PLANNING, ZONING, & BUILDING DEPARTMENT
PZ&B Staff Combination Memorandum: Architectural Commission and Town Council

SUBJECT: ZON-24-063 (ARC-24-065) 137 E INLET DR (COMBO)

MEETING: MAY 29, 2024 ARCOM
JUNE 12, 2024 TC

ARC-24-065 (ZON-24-063) 137 E INLET DR (COMBO). The applicant, Ocean Inlet Revocable Trust, has filed an application requesting Architectural Commission review and approval for a driveway reconfiguration and installation of a vehicular gate requiring a variance. This is a combination project that shall be reviewed by Town Council as it pertains to zoning relief/approval.

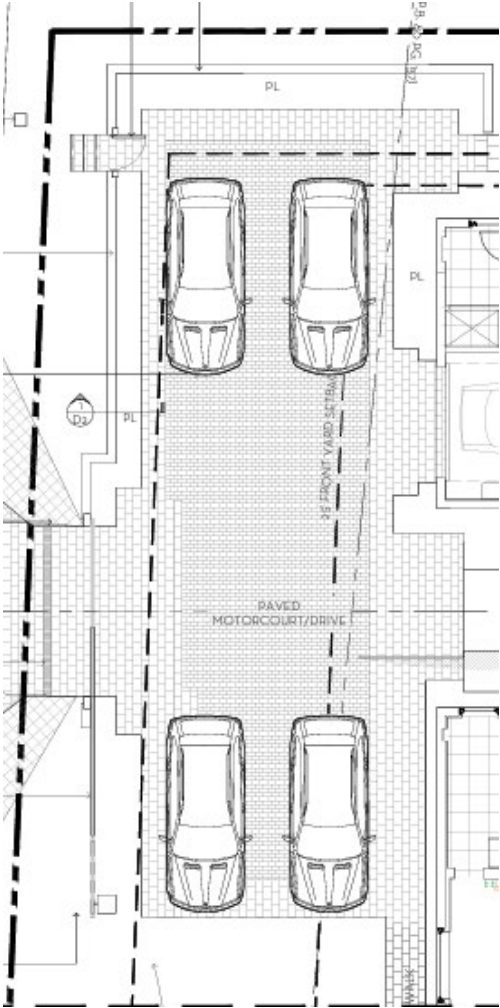
The applicant proposes to remove one of two curb cuts to create a single-entry driveway. New landscape and a wood pedestrian gate will be added in the area previously used as a driveway entrance increasing their open space calculations.

PROPOSED VEHICULAR GATE

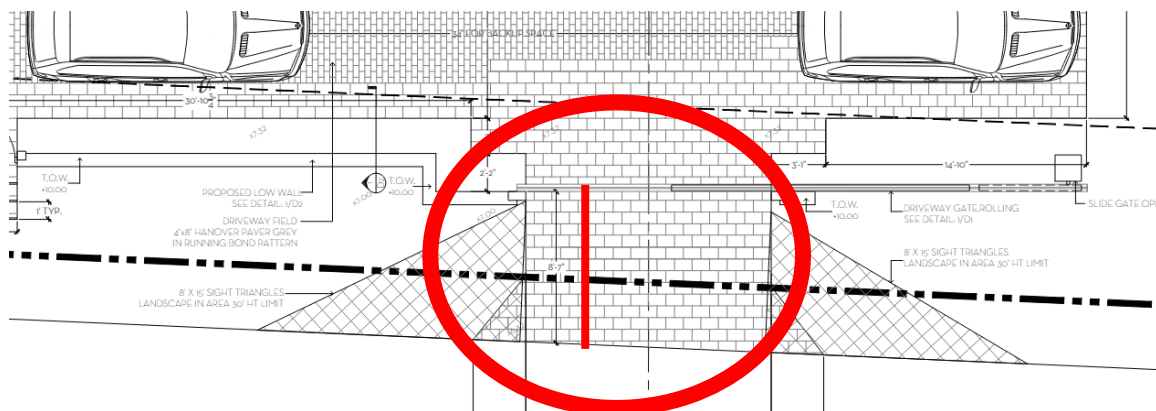
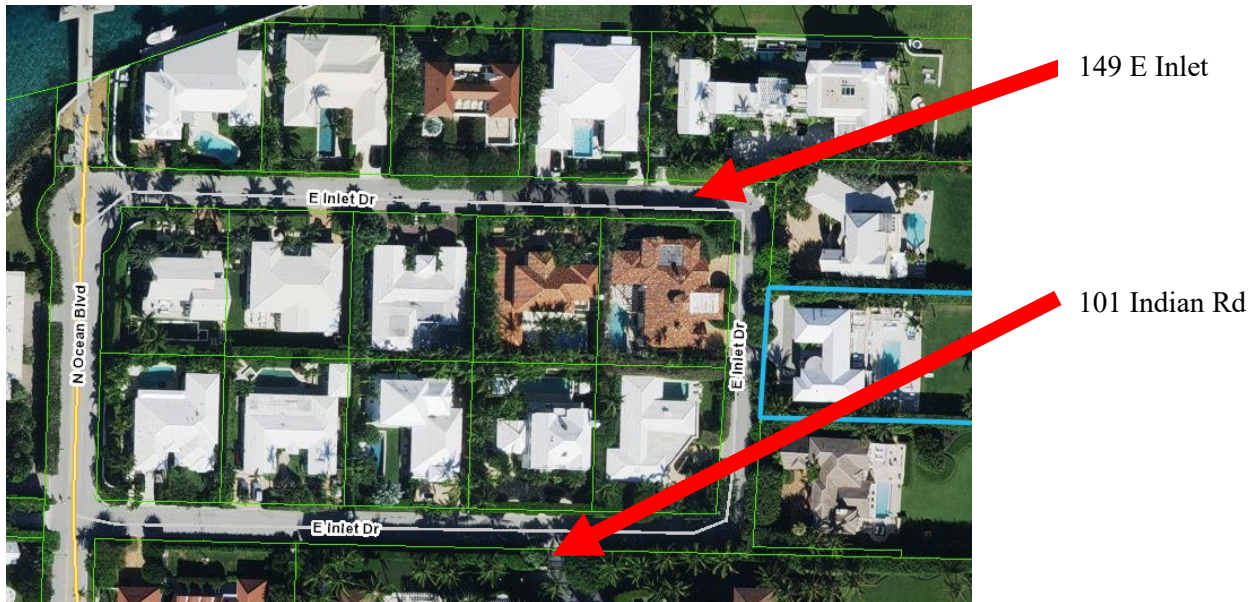
Matching in style and material commensurate with the style of house is a rolling vehicular gate which will be installed at 8'7" in lieu of the 18' required for vehicle queuing. The addition of the 4' high Ipe wood gate with matching gate will does alter the current transparency into the site.

Based on the surrounding area, the introduction of the gate would be inconsistent with the majority of the other residences that are without gates and would obstruct the site-wide openness of the front yard.

Additionally, the proposed gate requires a variance as the required backup space is not being met, potentially creating an unsafe condition or blockage within the roadway. The applicant has provided 8'-7" of clearance where 18'-0" is needed.
